Tahmoor South Project: Response to agency feedback on Second Project Amendment Report

This letter provides a response to the matters raised in advice from government agencies in relation to the *second amendment report* (EMM 2020) for the Tahmoor South Project (the Project), including:

Figure 1: Myrtle Creek M5 – Pool 23 Level Monitoring

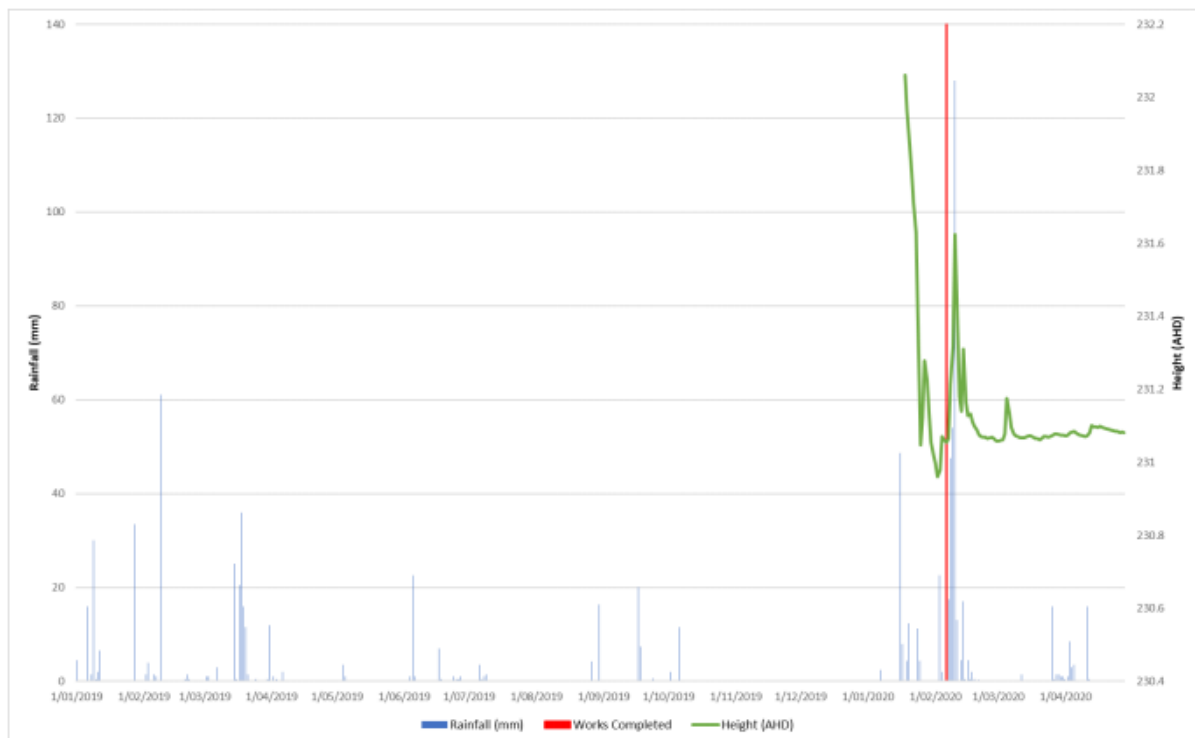
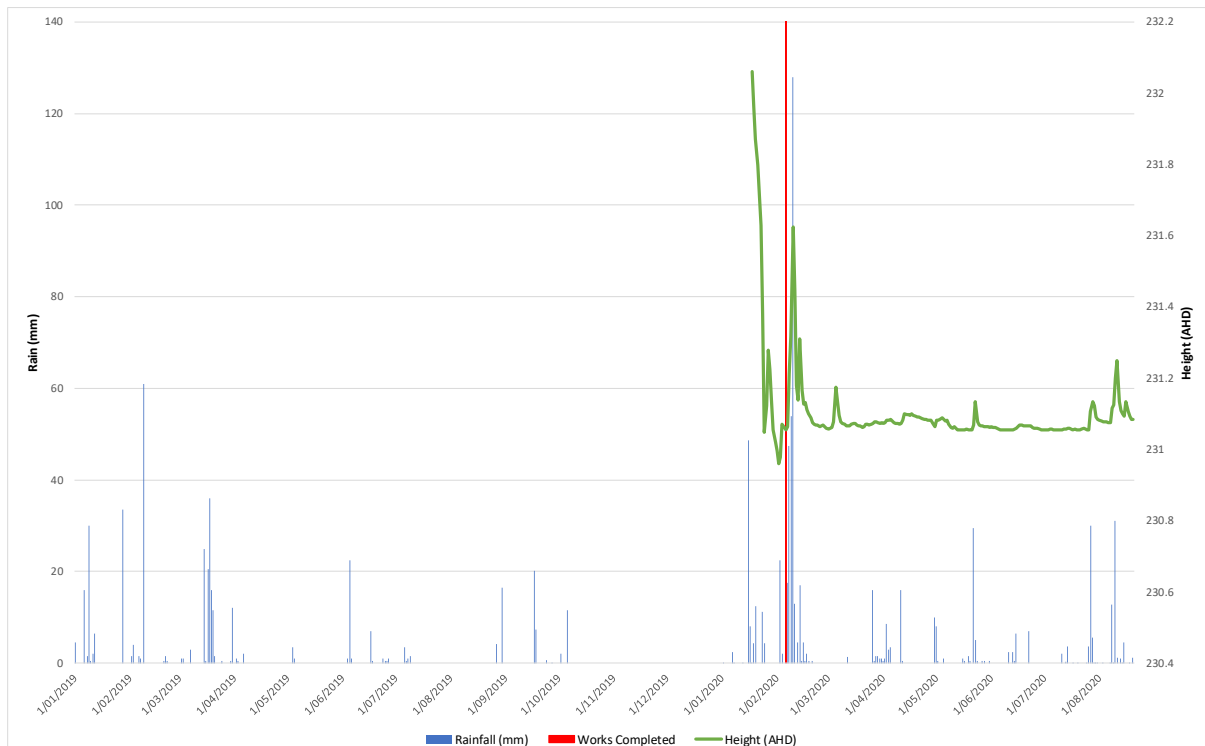
- Impacts to 3rd order Dog Trap Creek pools and flow will be almost inevitable given the proposed mine layout. Once impacted, Dog Trap Creek is unlikely to be repairable or continue to flow in the area of mining (except after heavy rain).
- Insufficient justification has been provided to demonstrate that impacts to undermined streams and watercourses, notably 3rd order streams Dog Trap Creek, will be repairable.

This quarterly CMAP report indicates that there has been success in remediating impacts to the creeks as a result of the works within the creeks. In particular, the report indicates that following works, within a section of Myrtle Creek, water levels have increased and been maintained. Section 2.3.1 of the quarterly CMAP report states:

Level monitoring is conducted at Myrtle 5 which is located within Pool 23. Figure 2 illustrates pool height level at Pool 23 with rainfall. Rainfall data is collected from the weather station located at Pool 23 from 11 October 2019 onwards and Tahmoor Coal mine site from 2010. Pool height is measured as zero if the monitoring equipment is not submerged in water. Prior to remediation works, rain events in 2019 had no noticeable impact to Pool 23 height due to subsidence impacts and its inability to competently hold water, hence no pool level was recorded. It can be observed, that following remediation works, Pool 23 has effectively filled to its full level which has since been sustained.

Figure 1 below is reproduced from Figure 2 of the quarterly CMAP report.

An extension of this graph is shown below as Figure 2 through until 20 August 2020, further illustrating that the water levels have been maintained following successful remediation.

Figure 3: Share of bore drawdown due to cumulative mining effects

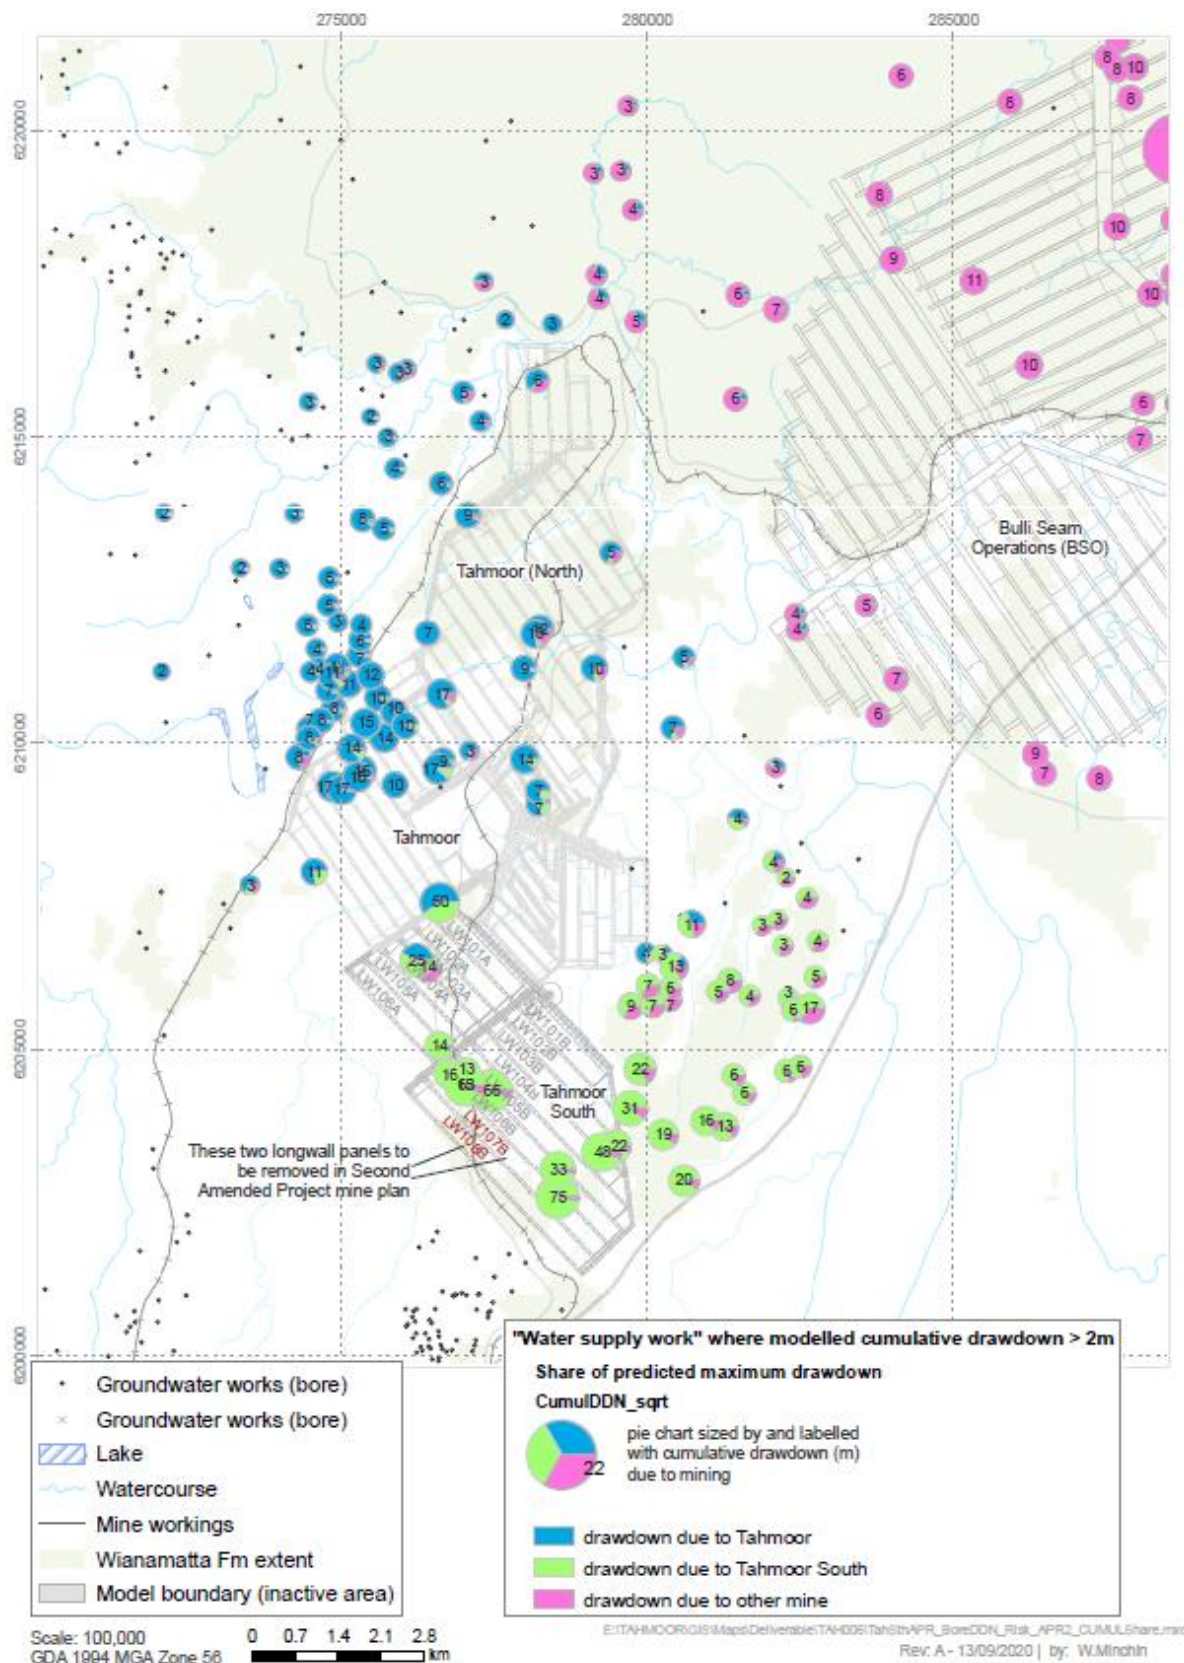
Provide further information on water supply bores which are predicted to be impacted by cumulative groundwater drawdowns in excess of the 2 m drawdown criterion of the AIP and that may require make-good provisions. Information should include how make-good requirements would be managed between the applicable mines (ie. Tahmoor North, Tahmoor South, BSOs and Dendrobium).

Figure 33 presents the results of the modelled assessment of maximum drawdown due to mining for all bores where the cumulative drawdown is predicted to be >2 m. The figure illustrates the total predicted drawdown and illustrates that share between Tahmoor (north), the Project and other mines (specifically the BSO Mine), which is located to the north and east of Tahmoor.
